SUMMARY OF COMMENTS/RECOMMENDATIONS

PROPONENT: Municipality of Harrison Park
PROPOSAL NAME: Sandy Lake Water Level Control Project
CLASS OF DEVELOPMENT: Two
TYPE OF DEVELOPMENT: Water Development and Control
CLIENT FILE NO.: 5804.00

Response to August 18, 2016 Request for Additional Information

Re: **Sandy Lake
 Water Level Control Project**

DATE: OCTOBER 2015
SCALE: (H) 1:250 (V) 1:50
DRAWING 2

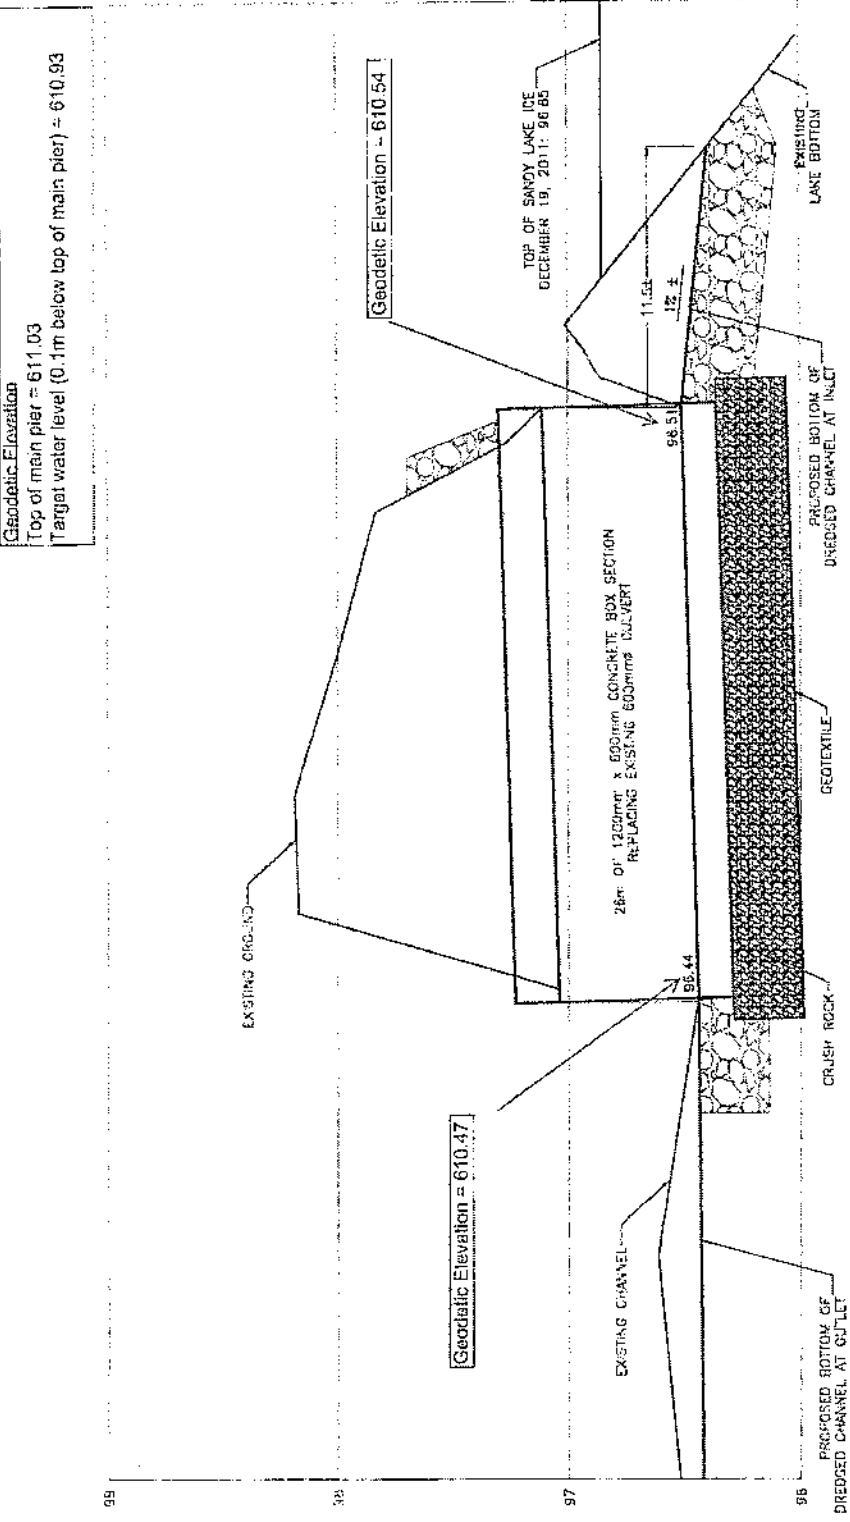
1. Lack of geodetic level to indicate what static level that Sandy Lake will be maintained or where the gate will be established. Clearly this is an important for understanding the impact to current levels and how much drawdown is required to

get to that level. As the proposal mentions that the target level is 0.1 m below the top of the pier, it has been noted that the pier was not level at last inspection and also was scheduled to be removed January 2016.

Suggestion that a geodetic level be incorporated in the report as well as information as to how much draw down required of current lake level.

1. The proposal references a target water level for the lake to the main community dock (0.1 m below the top of the dock). I understand the dock has since been removed. A geodetic level for the target elevation is needed. Are there plans to establish another convenient reference point for monitoring water levels?

The geodetic elevation of the top of the main pier was at 611.03. The goal is to lower the lake level to 0.1m below the top of the main pier to an elevation of 610.93.

The target water level of 0.1m below the top of pier was just used as an easy reference for the public. During survey and construction, numerous benchmarks will be available to be used as a reference point for monitoring water levels.

Rick Pemkowski, the local water resource officer, was contacted regarding the need for an engineered drainage plan. He stated that all he would need, aside from the stamped plans included in the EAP, are geodetic elevations for the proposed culvert and the target water level. See the attached Drawing for the relevant geodetic elevations. A copy of the attached drawing has been forwarded to Rick Pemkowski.

Geodetic Elevation
Top of main pier = 611.03
Target water level (0.1m below top of main pier) = 610.93
